**ADDENDUM NO. 2
TO CONTRACT DOCUMENT PLANS SPECIFICATIONS**

**PROJECT: MWA METRO PARK WEST LANDFILL
P-67 CELL E LINER, LEACHATE LAGOON, AND SED POND**
TO: PROSPECTIVE BIDDERS AND OTHER INTERESTED PARTIES

SHEET C507

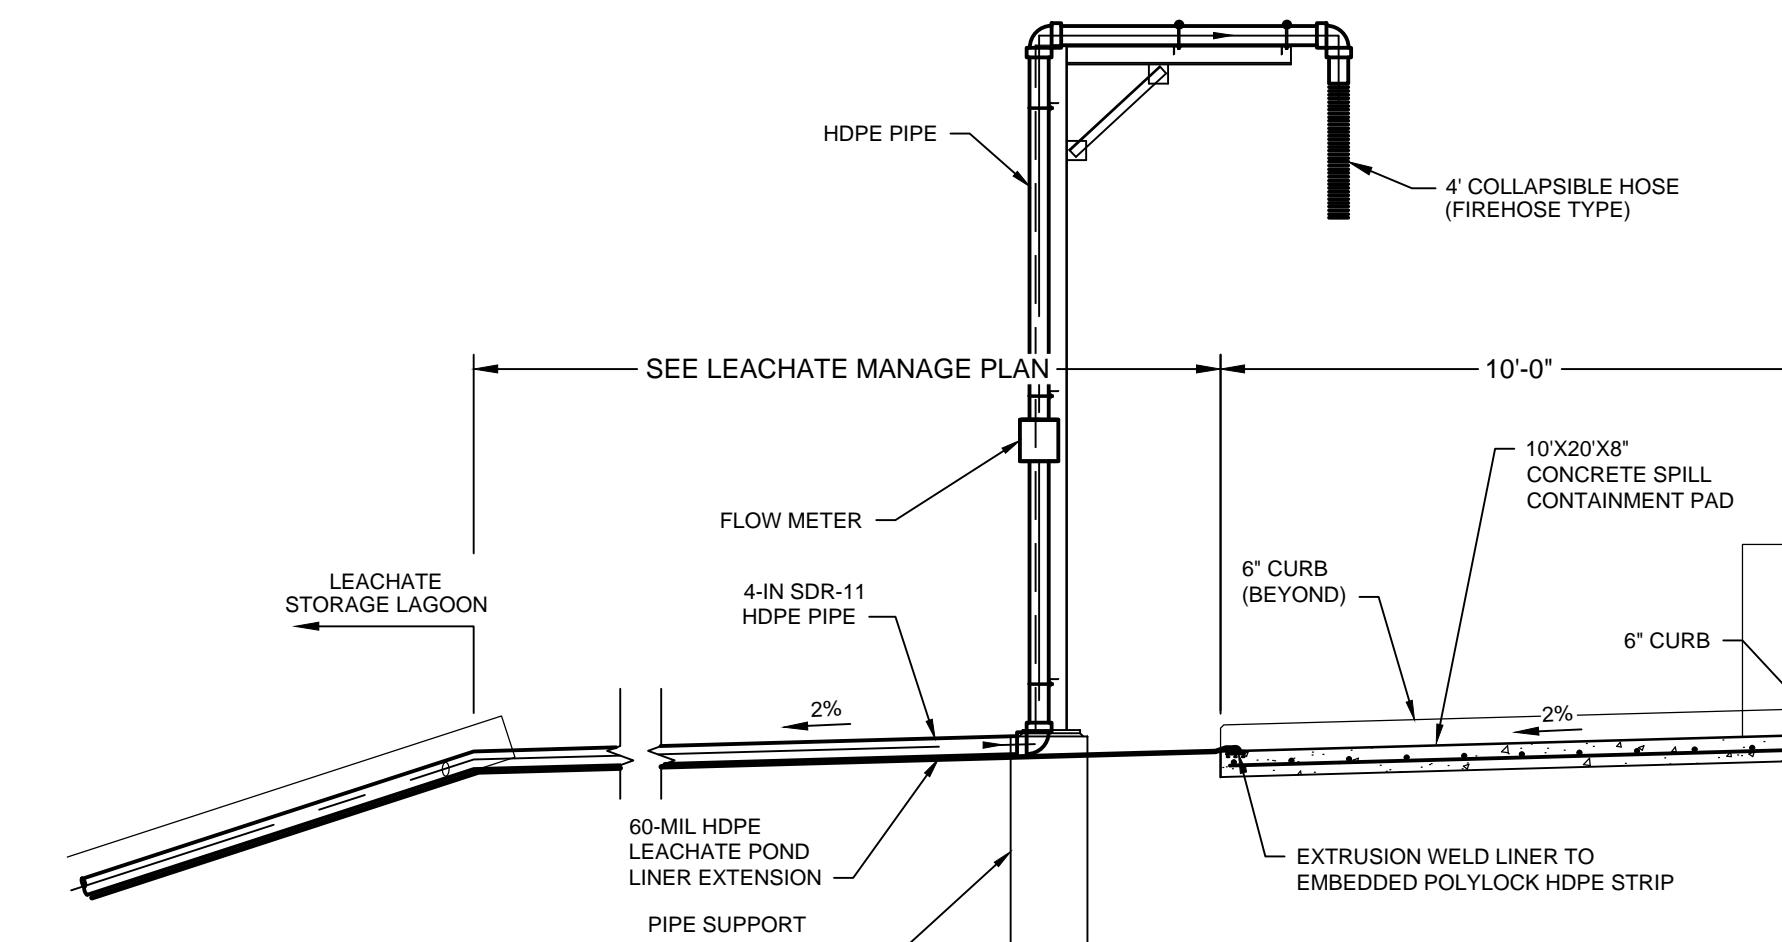
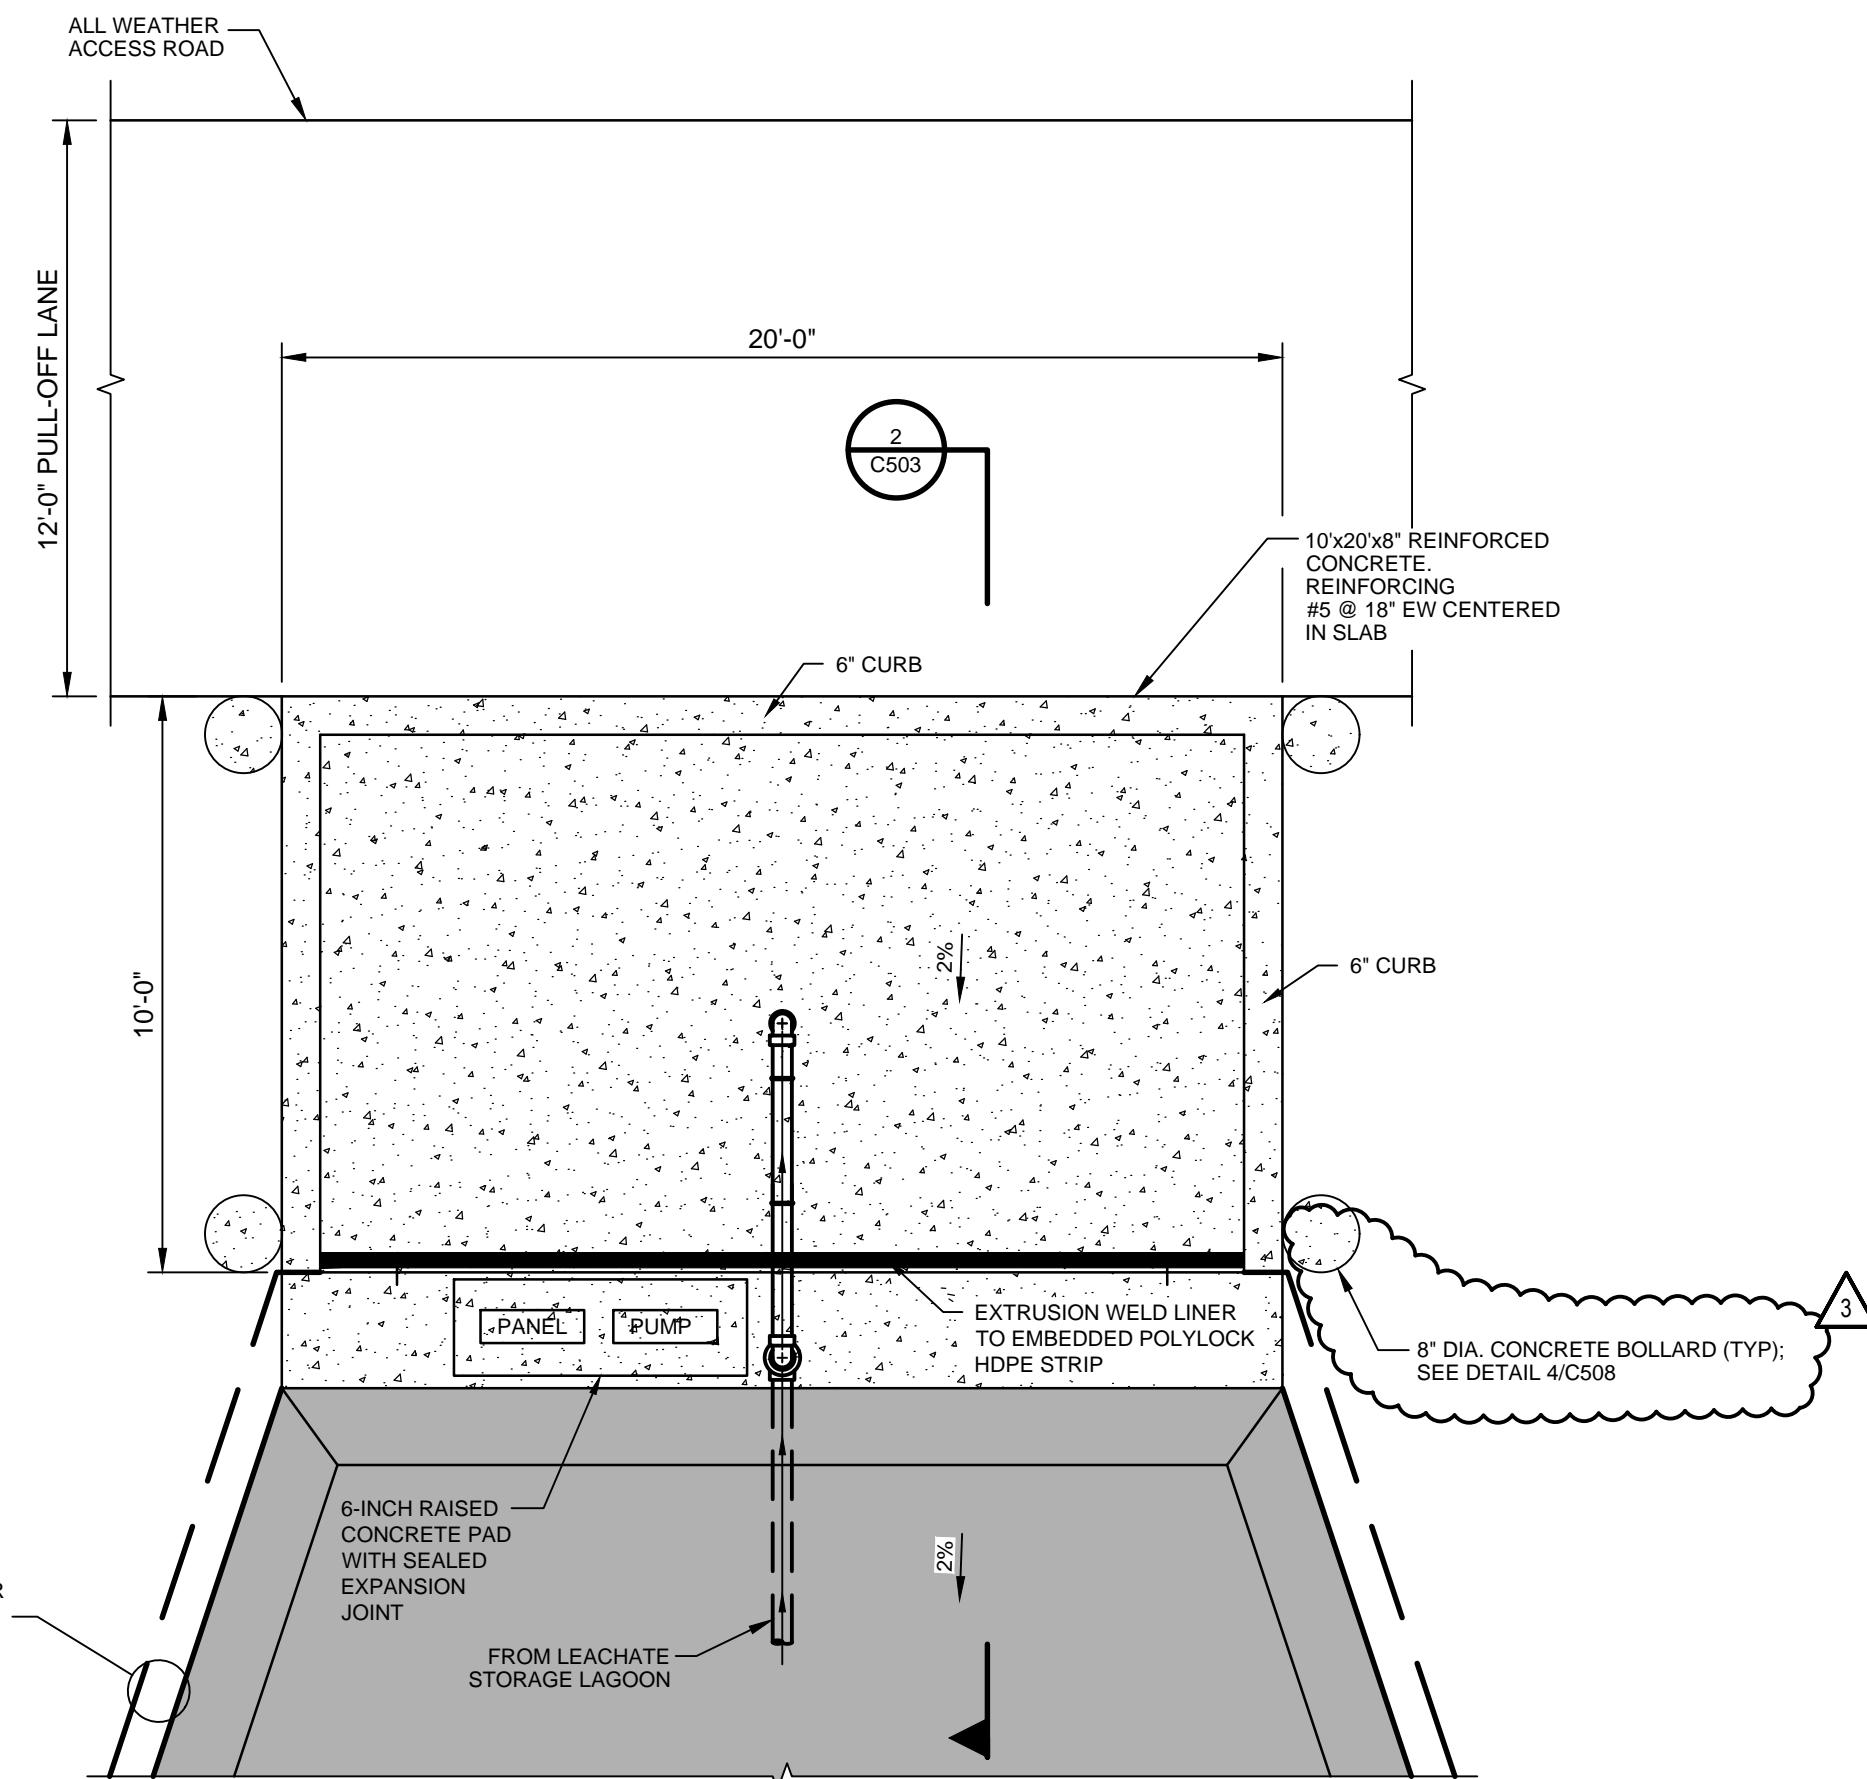
Question 3: *There is a 24" detail for the CMP coming out of the 36" CMP risers – but is also 36" in other details – please clarify.*

Question 36: Sheet C507, Detail 1, shows grating on top of the drop inlet structures, please clarify what this grating is to be.

Answer 3: Riser pipe for standpipe shall be 48" diameter per Detail 1, Sheet C507.

Answer 36: Grating to be beehive grate (Neenah 4340-A or approved similar) with top cover to fit grate onto inlet.
